Service Bulletin

Bulletin No.: P11339

Subject: Service Side Detection System Message Displayed on Driver Information Center (DIC)

Models: 2015 Cadillac CTS Sedan (VIN A)
Built Prior to September 8, 2014

3988678

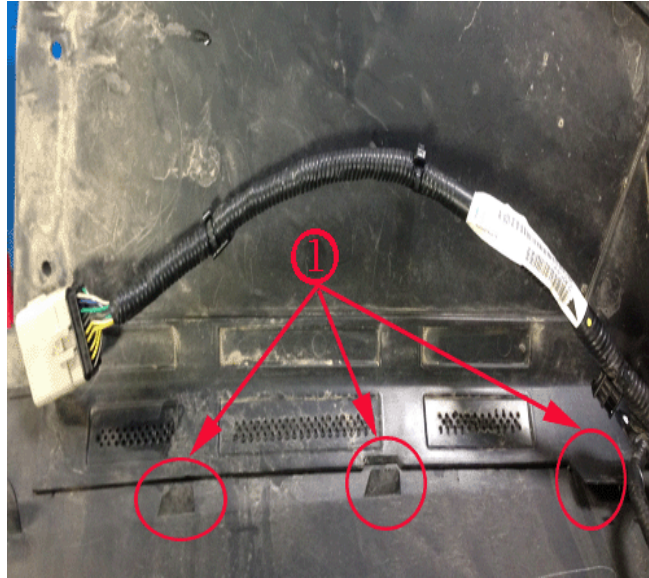
- Identify if the left or right side object sensor module (1) is not retained in the bracket properly and identify if the module's connector (2) is not fully seated.

Adhesive patches should be installed to the left and right side object sensor modules to ensure a future occurrence does not happen.

3988938

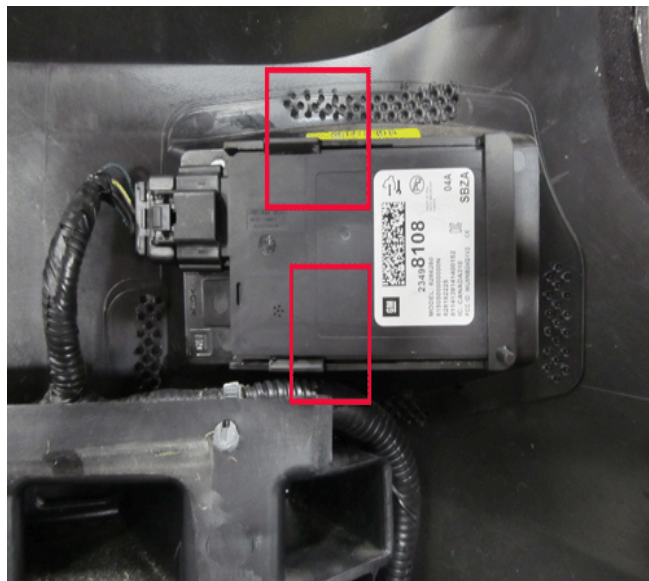
- Inspect the rear fascia harness retainers (1) for being loose.
2. Secure the side object sensor modules and the fascia harness retainers, if necessary.

3988951

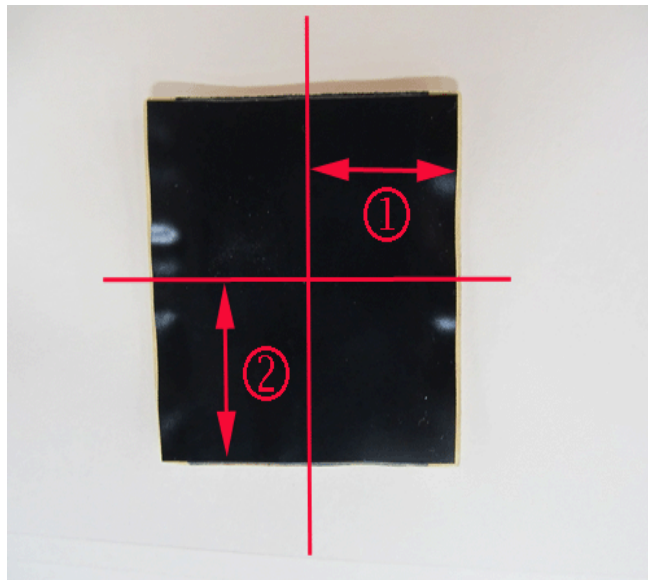
3. Clean the bracket and the module surface area as indicated above with Kent® Moulding Adhesive Promoter or equivalent.

4. Cut the Kent® adhesive Posi-Seal Plus Patch or equivalent into four pieces, width (1) 31.75 mm (1¼ in) and height (2) 31.75 mm (1¼ in) as shown above.
5. Install the adhesive patch over the locking tabs of the bracket as shown above.
 - Ensure not to cover the holes (2) of the modules.
 - Ensure not to cover the label (3) of the modules.
6. Reinstall the rear fascia. Refer to the Rear Bumper Fascia Replacement in SI.
7. Clear any related codes.
